# City of Sanibel

## COMMUNITY SERVICES DEPARTMENT Planning Staff Report

September 14, 2021  
No. 7c.  
21-12854DP  
Benchmark General Contractors, Inc., on  
behalf of property owner Nancy Tatko Trust

**RE:** Consideration of a **Development Permit** application filed pursuant to Land Development Code Chapter 126 – Zoning, Article XIV – Supplementary District Regulations, Division 15 – Elevated Swimming Pools, Section 126-1302 – Requirements and procedures, to construct an elevated swimming pool as an accessory structure to an existing single family residence at 5029 Joewood Drive. The proposed swimming pool is to be elevated higher than 7 feet above predevelopment grade of the subject parcel and therefore is required to be considered as a long-form application. The subject property is located at 5029 Joewood Drive (tax parcel no. 19-46-22-T1-00100.0060). The application is submitted on behalf of the property owner, Nancy K Tatko Trustee for Nancy K Tatko Trust by Benchmark General Contractors, Inc. **Application No. 21-12854DP**

EXISTING ENTRY DECK PLAN (DEMOLITION PLAN)

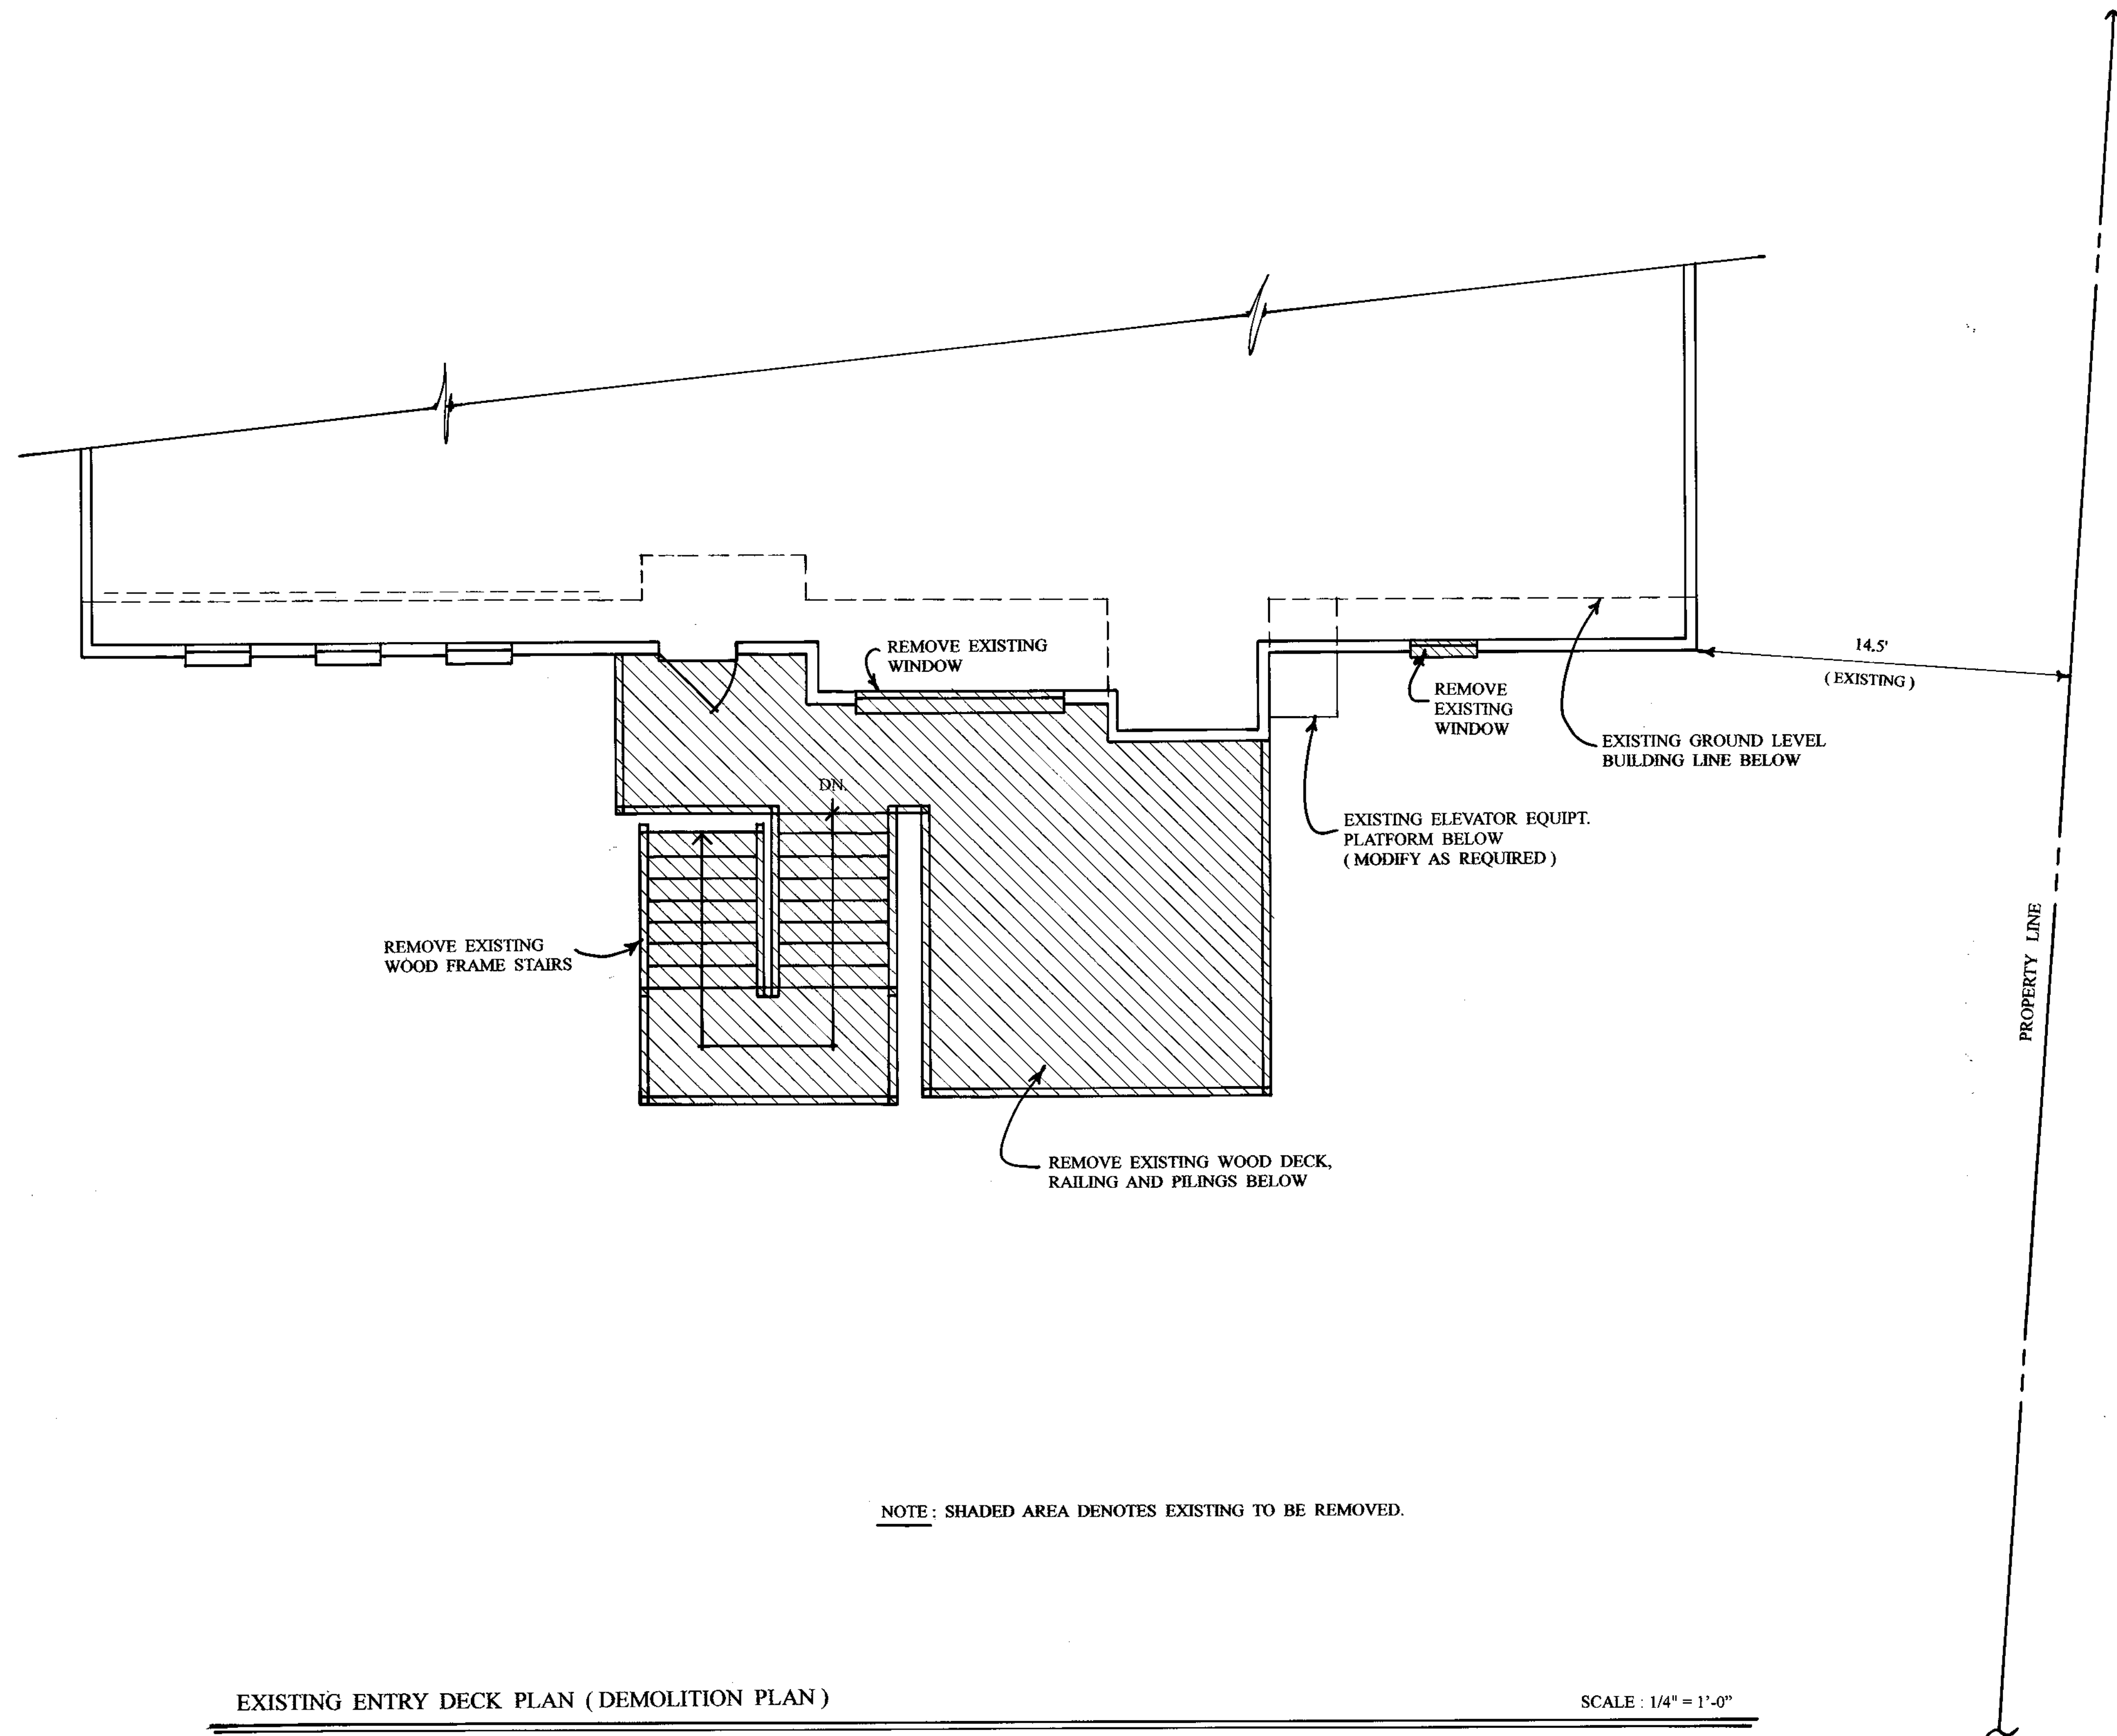
The applicant proposes to remove the existing wood frame entry stairs and elevated wooden deck, including the support pilings (see Sheet A-3 of **Attachment D**, the proposed plans). The elevated swimming pool is proposed in the place of the existing stairs and elevated deck on the northwest corner of the residence. The pool will be elevated by concrete pilings with the pool equipment and crushed shell placed underneath the elevated structure. The area below the pool is proposed to be enclosed with breakaway walls and hydrostatic relief flood vents as required by the *Florida Building Code* and Sanibel flood regulations.

ELEVATED POOL PLAN

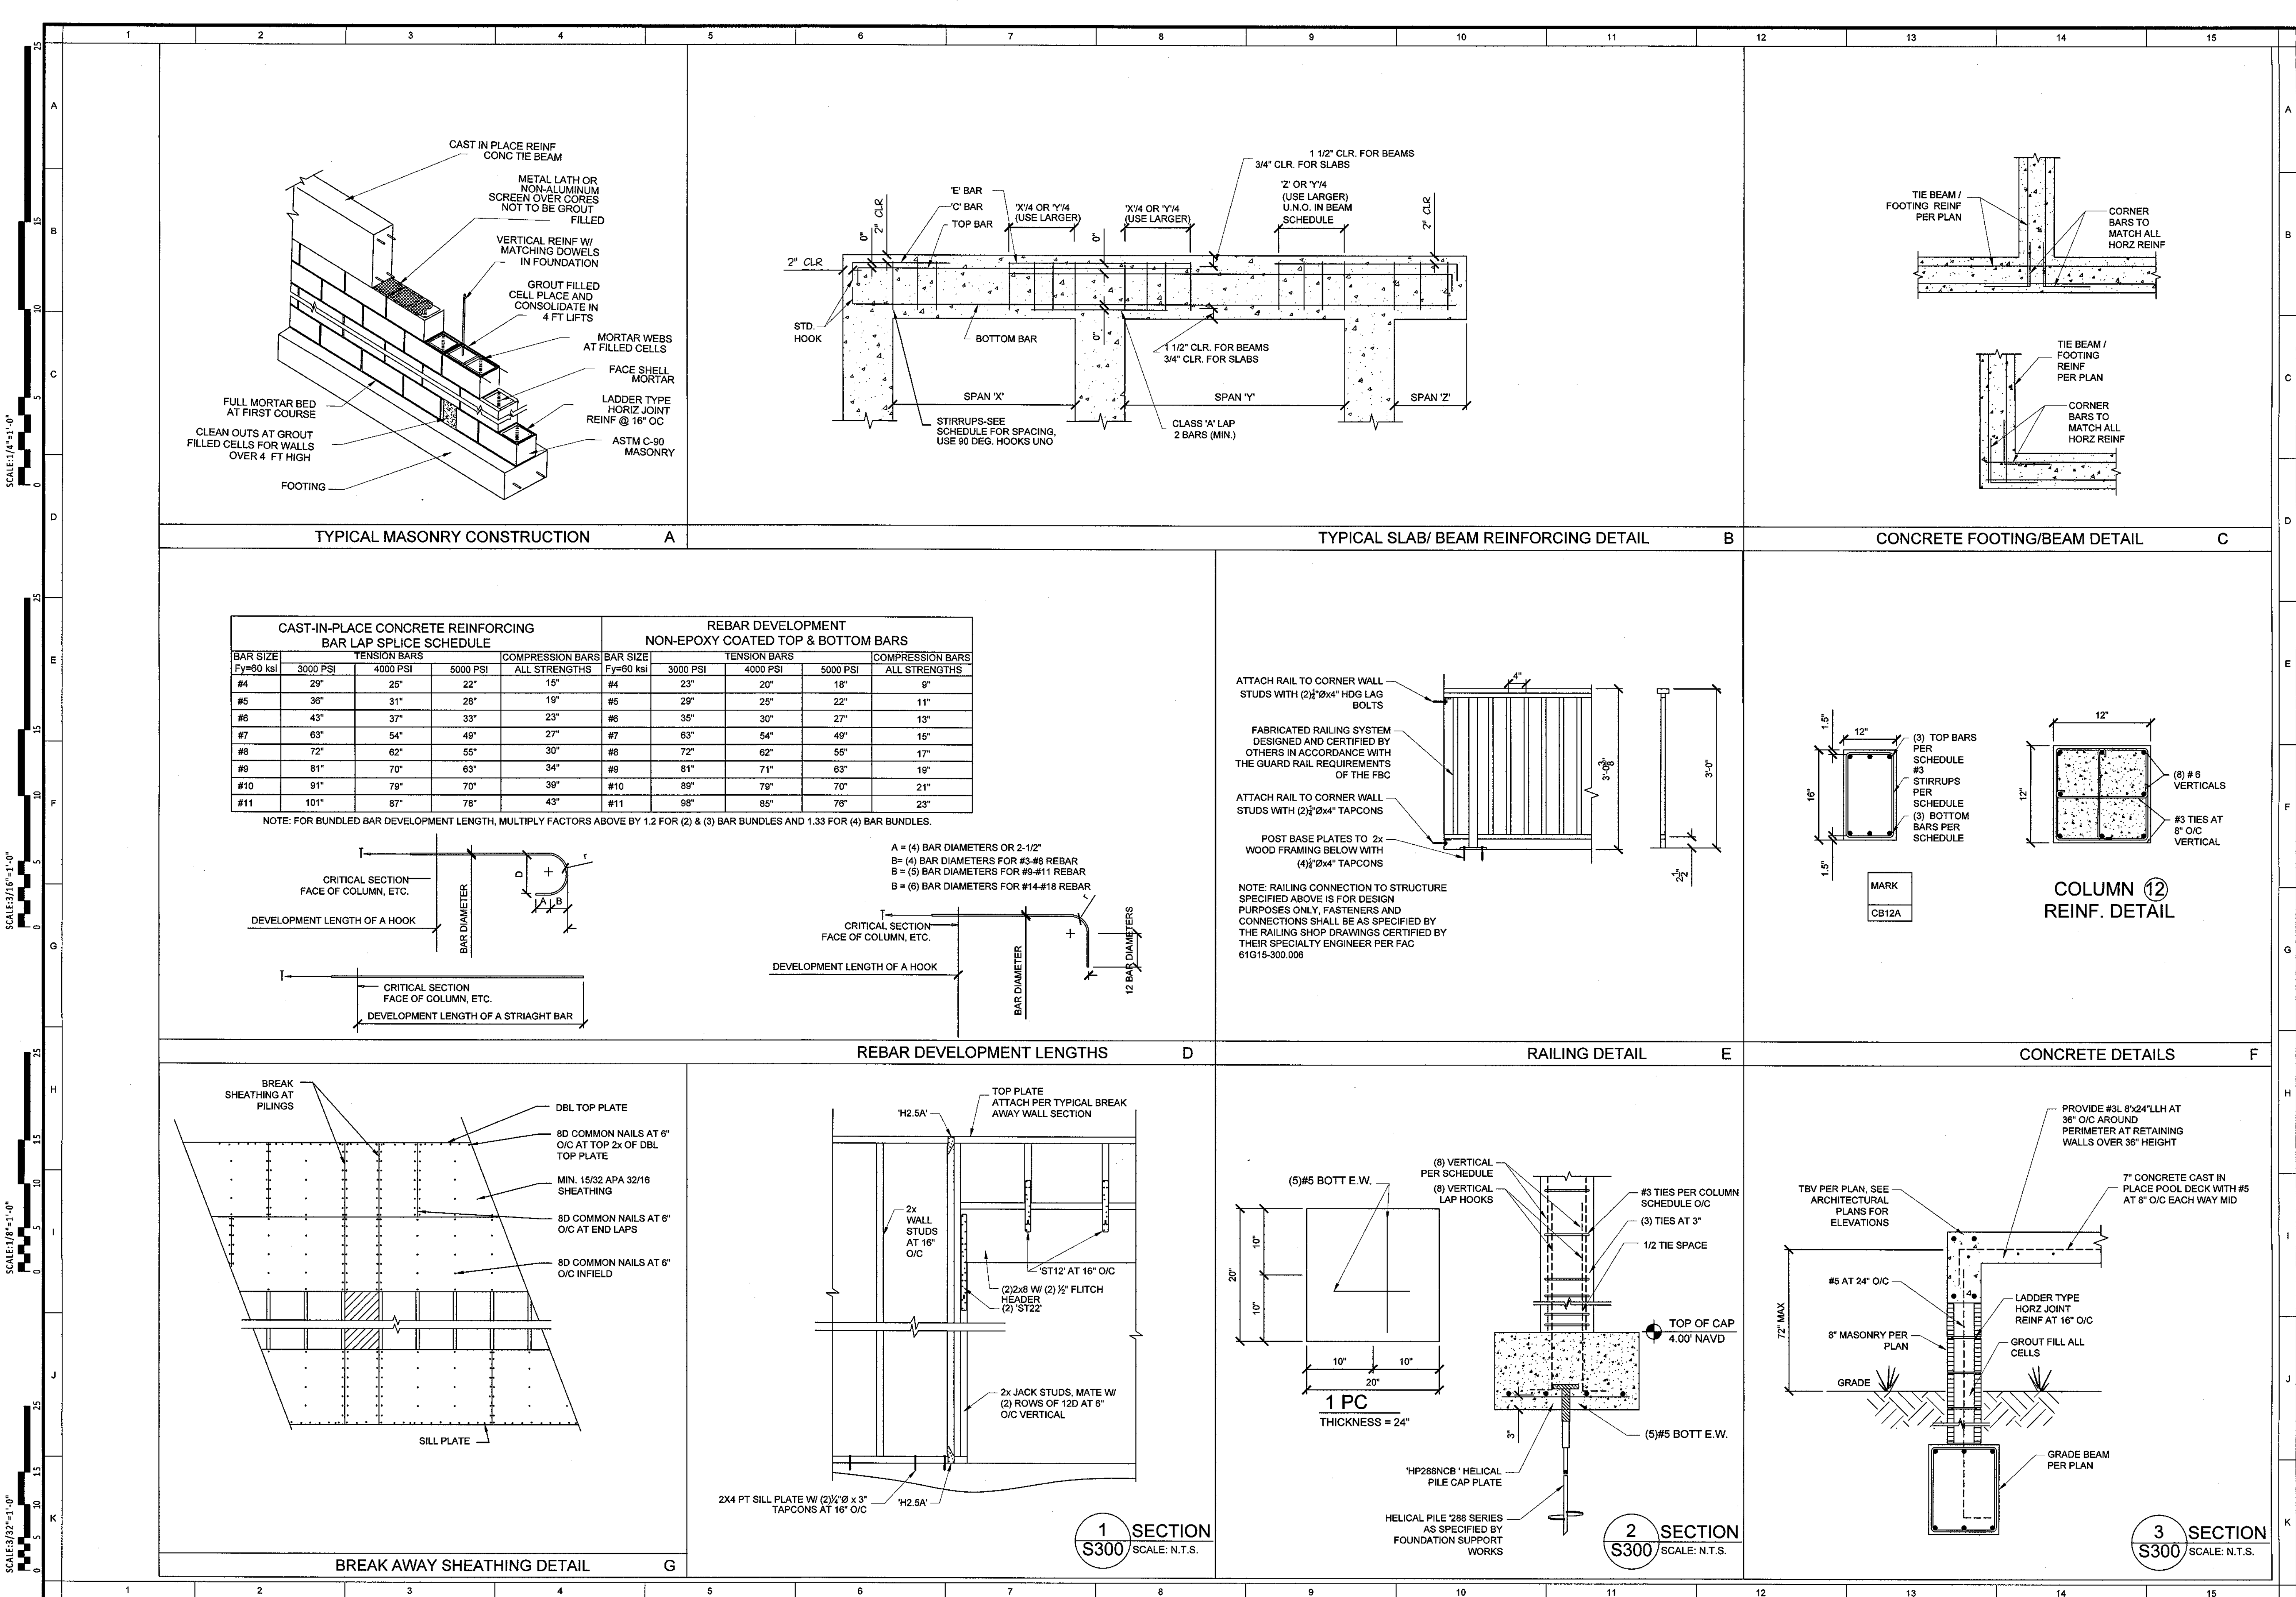
- Staff Comments: The proposed elevation of the swimming pool deck (+13.9 feet) is designed to match the existing elevation of the lowest floor of the residence.

3. The height of the deck for the proposed elevated swimming pool shall not exceed an elevation of +13.92 feet NAVD.
4. The wall height of the screen enclosure shall not exceed the height of the elevated living level of the residence, and the overall height of the screen enclosure shall not exceed the height of the principal structure's roof.
